Re: Feedback on 2026 RTEP Assumptions (as presented at the April 7, 2026, TEAC)

Comments of FirstEnergy to PJM Planning Staff on 2026 RTEP 8-Year Capacity Expansion Assumptions

Maryland DNR Power Plant Research Program Response to 2026 RTEP Assumptions

Figure 4: 2024 – 2033 ELCC Class Ratings for 4-hr Storage, 6-hr Storage, Solar Hybrid Open Loop (OL) - Storage Component, Solar Hybrid Closed Loop (CL) - Storage Component

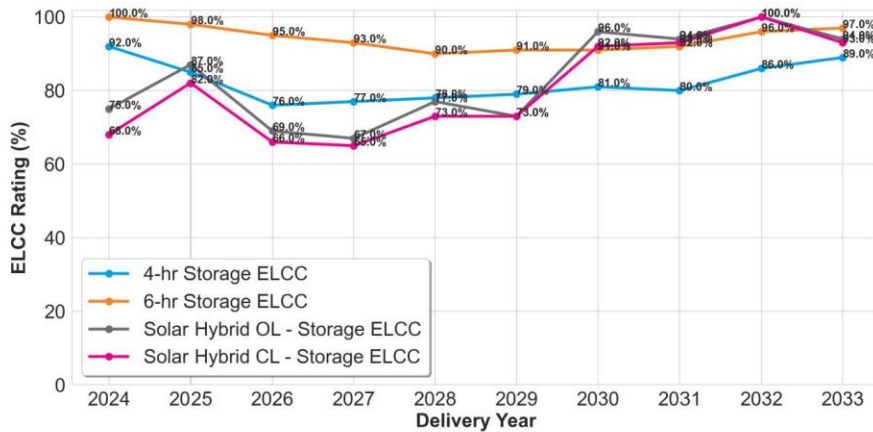
1. Could you please explain why hybrid solar+storage resources will only receive half of the ELCC of a battery plus the full ELCC of a solar resource. Why shouldn't the hybrid resource receive the full ELCC credit of a battery? How does the team reconcile this assumption with PJM's 2023 ELCC report, which calculates hybrid solar+storage resources achieving ELCC values between 0.65 and 1 and, especially, increasing over time? See excerpt from PJM's 2023 ELCC report below:

Figure 5: National average capacity credits vs. generation shares across technologies. The x-axes are the ratios of solar PV generation, onshore wind, and offshore wind over total system generation, and ratios of 4-hour and 8-hour battery capacities over total system capacity.

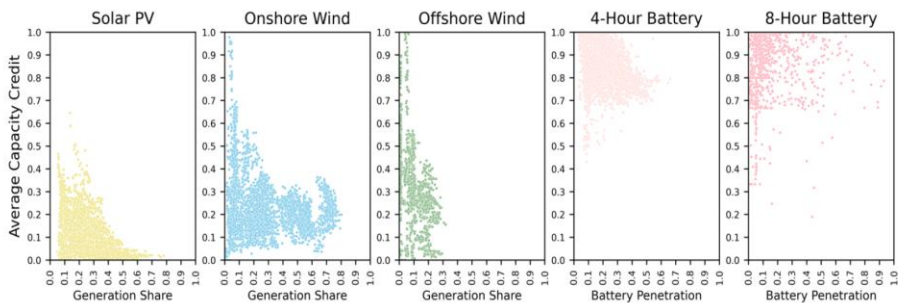
- Could you please explain why the ELCC of a battery declines with increasing penetration? Why does PJM assume that battery ELCC declines with greater battery penetration in two of three summer scenarios and all three winter scenarios, when NREL modeling shows that battery ELCC stays fairly high (between 0.7 and 1) over various levels of penetration and various weather scenarios (see attached NREL report)? See excerpt from NREL report below:

- Could you please explain why the ELCC of battery resources is consistently much lower in the summer than in the winter? Why does PJM think the ELCC of battery resources will be consistently low (0.6 to 0.3) in the winter scenarios, when NREL's calculations show battery resources achieving such low ELCC values only rarely (see same attached NREL report and same excerpt above)?

KEY TAKEAWAY

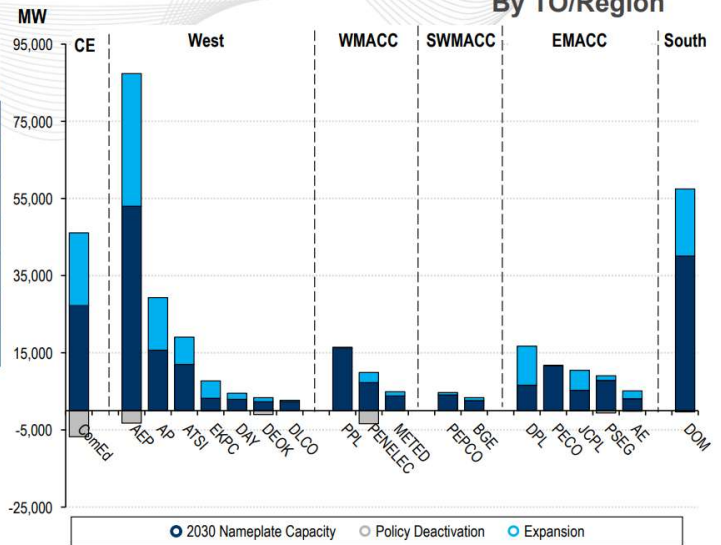
- ComEd and West accounts for 66% (81 GW) of 123 GW of capacity expansion.
- Most of the expansion is forecasted in AEP (34 GW), CE (19 GW), DOM (17 GW), AP (14 GW) and DPL (10 GW).

- Under Scenario A (Base Case for 2034), PJM does not plan to model new gas generation in NJ, MD, DE, and IL, aligning with those states' clean energy mandates. However, it is unclear why PJM also excludes new gas in eastern Pennsylvania. Unlike NJ and MD, Pennsylvania has not enacted a “Carbon Free” mandate prohibiting gas expansion. In fact, Pennsylvania’s policies and tax incentives for energy infrastructure indicate continued support for gas as a transitional resource. Over the past decade, eastern Pennsylvania has been one of the focal points of greenfield gas development in PJM. In particular, the PPL and MetEd zones have seen the highest concentration of new gas builds in PJM’s footprint because they sit directly on the edge of the Marcellus Shale production area. Modeling a “hard stop” to this established trend in the 2026 RTEP deviates from geological and economic realities. Given strong demand growth in eastern PA, including new gas generation in this region will better reflect current state policy and avoids overstating transmission needs. PPL also notes that initial applications in PJM’s Generation Cycle 01 show significant natural gas submissions in the PPL region, further confirming that PJM’s proposed assumptions are inappropriate.
